NAC Storage Transport Cask

RAI Response Supplement Package

Docket No. 71-9235

Subject: Submission of Supplemented Responses to NRC Request for Additional Information for NAC's Request for an Amendment of Certificate of Compliance (CoC) No. 9235 for the NAC-STC Cask

Figure 2.12.6.12-5:

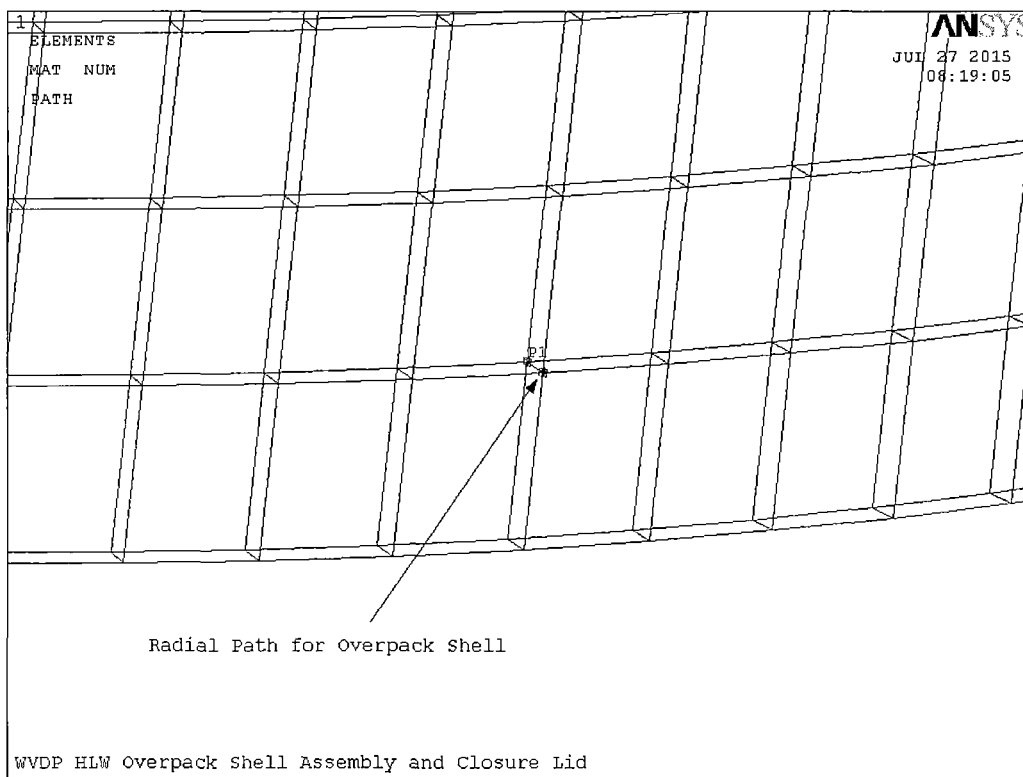
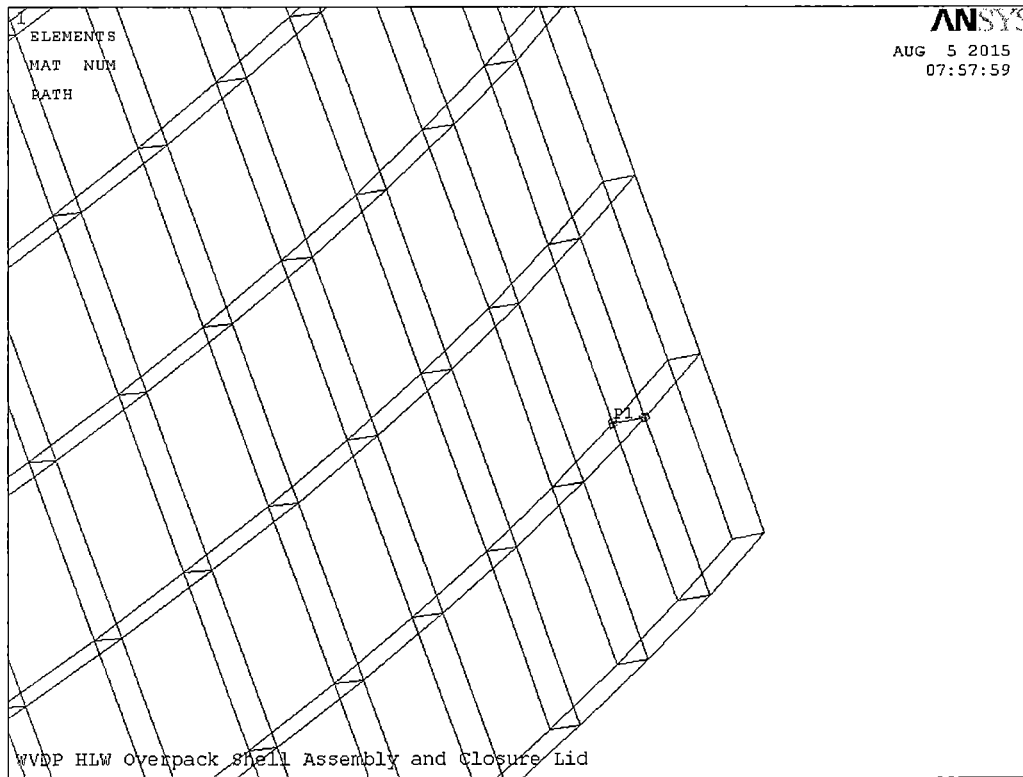
Figures 2.12.6.12-5 and 2.12.6.12-9 have been revised and updated on SAR pages 2.12.6-14 and 2.12.6-20, which are being provided along with their respective backing pages, 2.12.6-13 and 2.12.6-19.

Figure 2.12.6.12-5 HLW Overpack Assembly– Side Drop Model

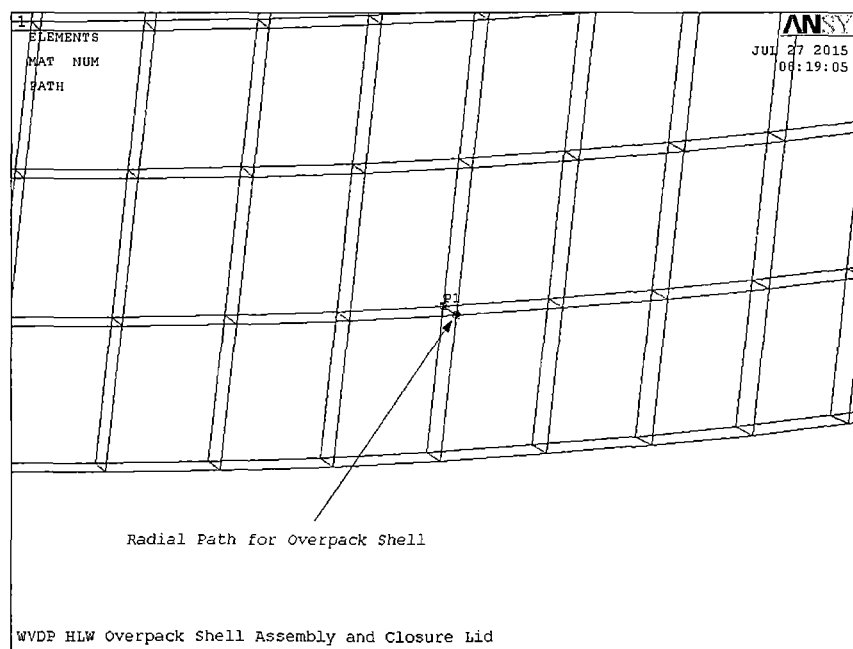
- Page 2.12.6-14, replaced Figure 2.12.6.12-5.
- Page 2.12.6-20, replaced Figure 2.12.6.12-9.
